Gap Validation report form for GS4GG project activities

BASIC INFORMATION		
Title and GS reference number of the PA	CTL Landfill Gas Project GS ref. no. – GS12062	
Version number of the validation report	2.0	
Completion date of the validation report	29/01/2024	
Version number of PDD to which this report applies	Version – 5 Dated- 27/01/2024	
Project Participants	EcoUrbis Ambiental S.A	
Host Parties	Brazil	
Applied methodologies and standardized baselines for the PA	ACM0001 – version 19.0 – Flaring or use of landfill gas	
Sectoral scopes for the PA (Indicate mandatory and conditional sectoral scopes)	Sectoral Scope 13 & 1	
Activity requirements applied	☐ Community Services Activities ☒ Renewable Energy Activities ☐ Land Use and Forestry Activities/Risks & Capacities ☐ N/A	
Product requirements applied	☒ GHG Emissions Reduction & Sequestration ☐ Renewable Energy Label ☐ N/A	
Sustainable Development Goals Targeted / SDG Impact	Estimated in PDD for the CP	Units or products

SECTION A. Executive summary

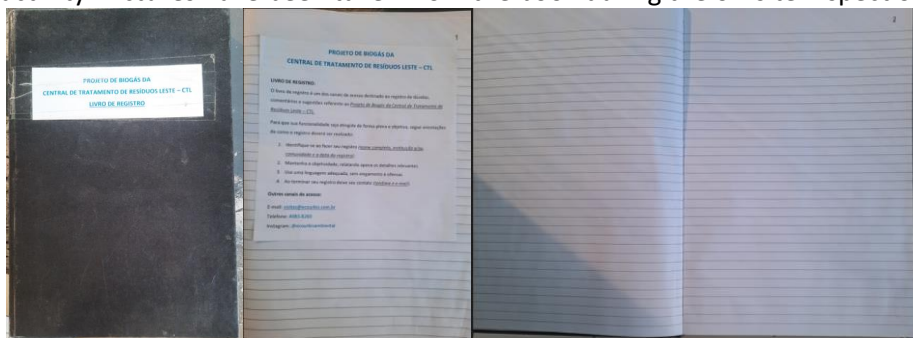
FAR ID	04	Section no.	x	Date : 14/01/2024
Description of CAR				
GS VVB shall validate how safeguarding principal assessments that require an Expert Opinion for the project type is completed				
Project participant response				Date : 14/01/2024
N/A				
Documentation provided by project participant				
N/A				
DOE assessment				Date: 22/01/2024

It is important to emphasize that the project activity corresponds to the implementation of biogas treatment plant in an operating landfill and it does not correspond to the implementation of the landfill. The project collects the biogas from a landfill which is already in operation and destroys it. Therefore, for the implementation of biogas plant, which is located inside the landfill, no impact in Sites of Cultural and Historical Heritage, Forced Eviction and Displacement, Land Tenure and other rights, Indigenous people, Labour Rights (child labour), Impact on Natural Water Patterns/Flows, Erosion and/or Water Body Instability or High Conservation Value Areas and Critical Habitats is expected. The only one that could be applicable to the project activity, which is labour rights (child labor), the VVB has interviewed the project developers and carry out an on-site inspection confirming that no child labor occur in the Biogas plant. During the implementation of landfill gas, all approvals have been granted by experts and therefore, they resulted in the issuance of environmental license of the landfill. But again, the landfill itself is not the project activity. Therefore, it is confirmed that all safeguarding principles that require expert opinion have been taken into account. Information has been included in section D.7 of the Validation report.

FAR to be checked during the next verification
